Below are our final comments on the marquee Multiproof application – after a review by Graeme. I have left the yellow highlights intact to show how they have changed from the previous email.

Please clarify the following items that were identified as a result of the assessment by our specialists:

Further from our discussion, below are the outstanding issues with Zirka's application. I have put them in a draft response form.

8 KING POLE

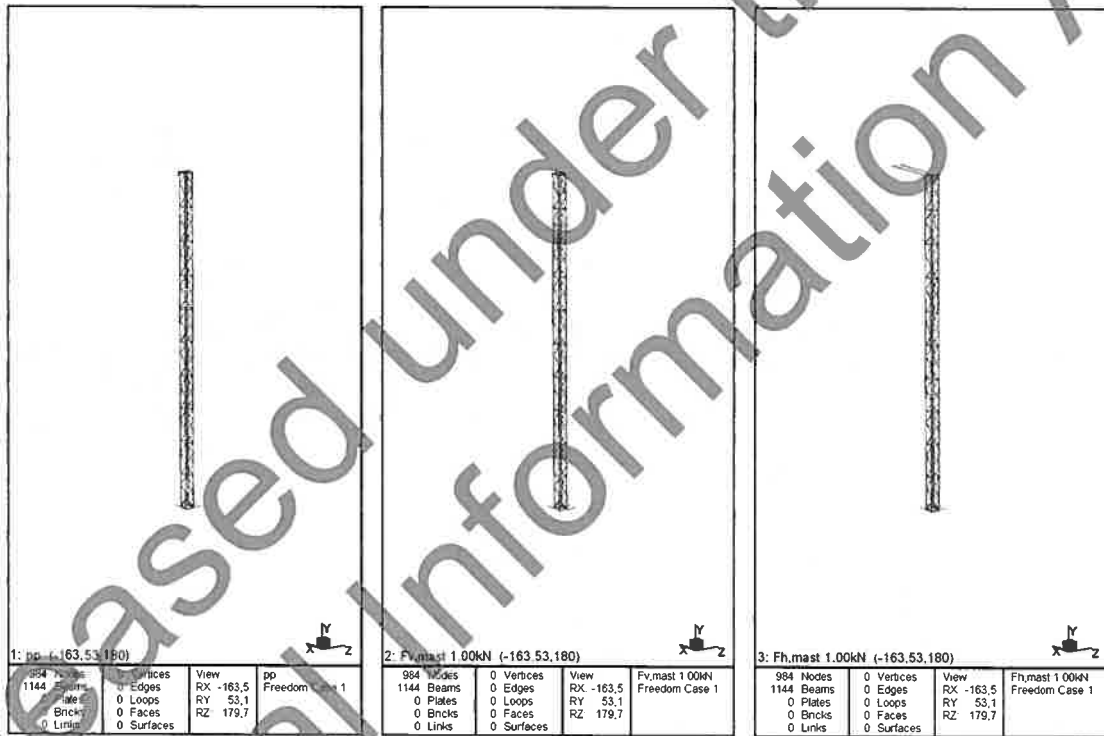
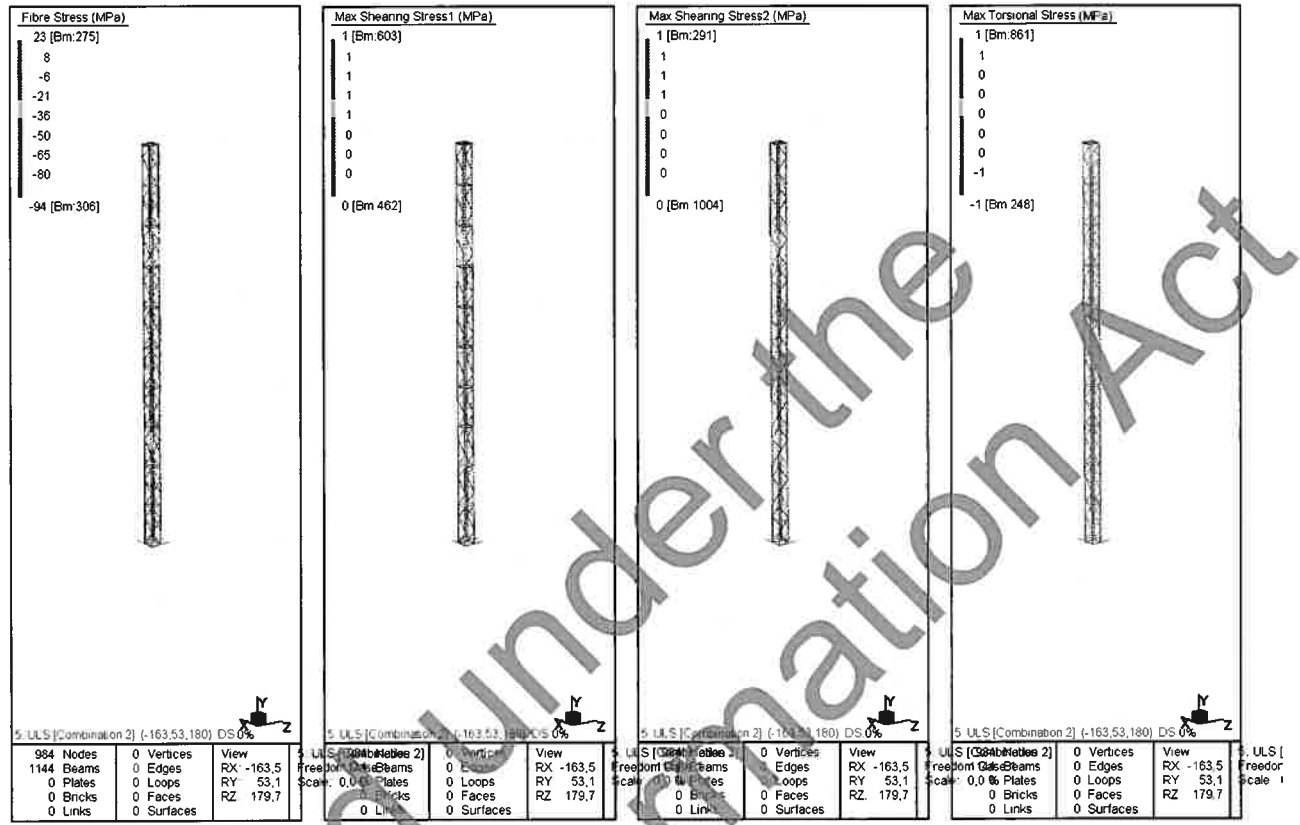
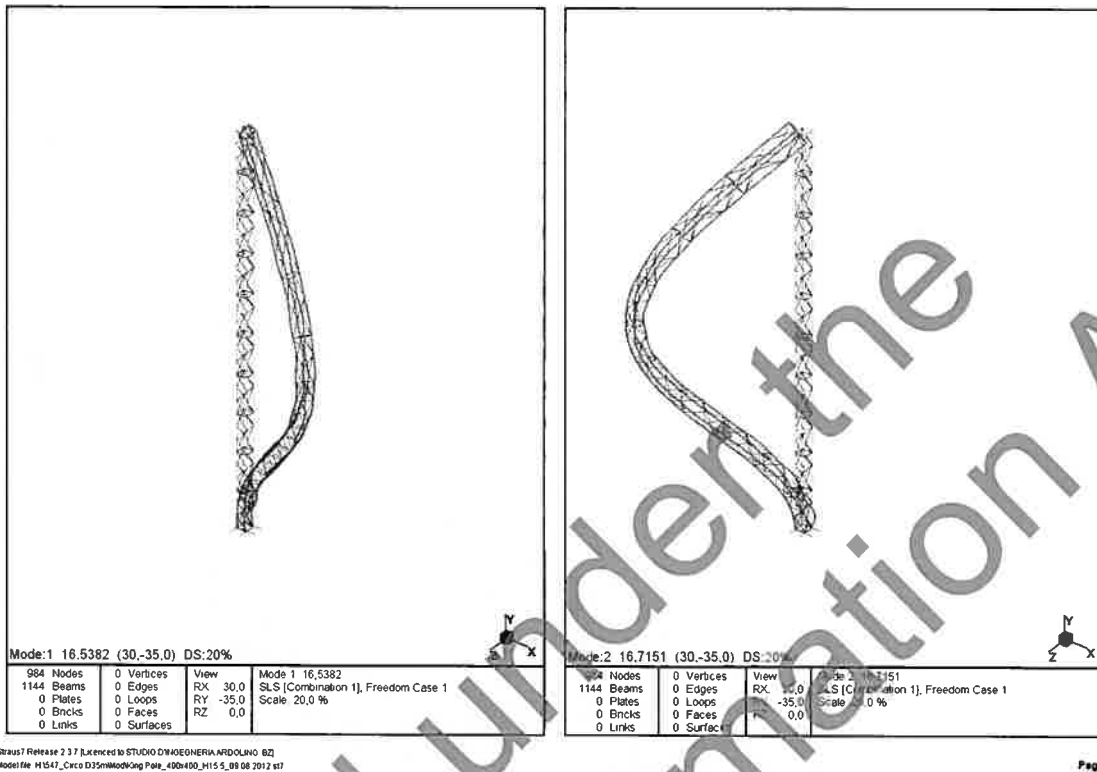
- More details of the poles/tent are needed [Graeme Lawrance] including compression capacity. [Graeme Lawrance] What is the purpose or purposes of the king post. The Plan and photos provided [Graeme Lawrance] are useful for getting an overview of the system but do not [Graeme Lawrance] provide sufficient detail. Sections and Detail [Graeme Lawrance] ed drawings will be required.

SOIL NAILS

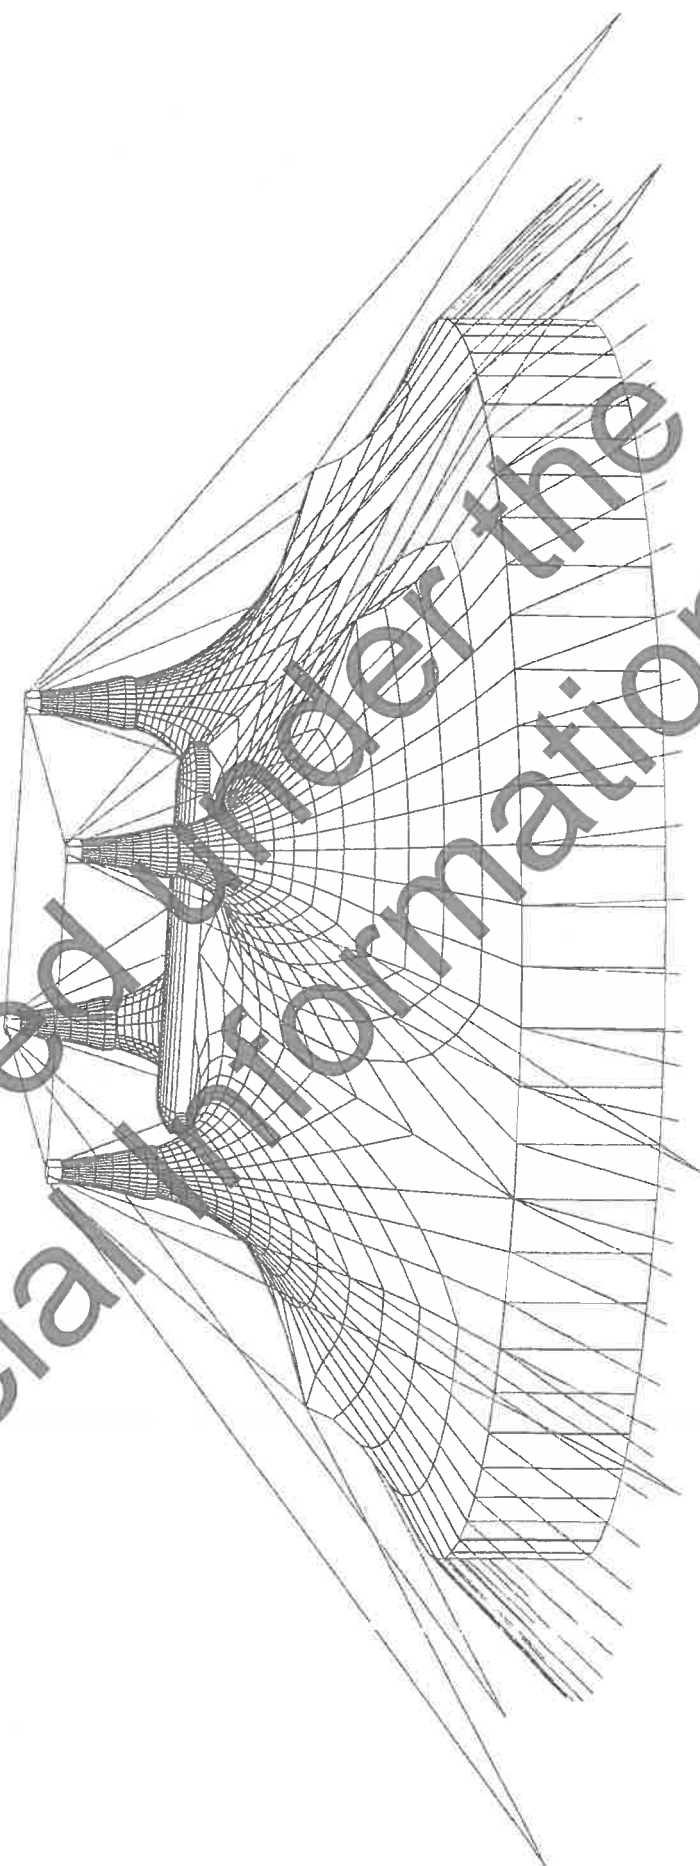
- iii) Redco assumed 'soft soils' as having adhesion of 10 – 33 kPa but calculated the 'most critical' case as 17.32kPa. This needs more explanation?
- iv) The peg's lateral capacity formula was calculated using Broms method but the equation used is different from Broms (1964)

- xvii) Pictures/photos of steel plate for guy-pegs are different from the sketch"
- xviii) Is there any test data to verify strength of pegs?

iii) Redco assumed 'soft soils' as having adhesion of 10 – 33 kPa but calculated the 'most critical' case as 17.32kPa. This needs more explanation?
This has been revised and explained in the summary page.

vii) 'Good ground' definition in NZS 3604:2011 excludes potentially compressible ground (i.e. soft soils) such as clay. The 'good ground' assumption is used in this design even for soft soils
This has been revised and we have restricted the design to "Good Ground" in accordance to NZS 3604.

ix) Is there any test data to verify strength of pegs?
There is no test data required for the pegs. There will be testing required if the circus marquee is to be installed on not "good ground" in terms of NZS3604.
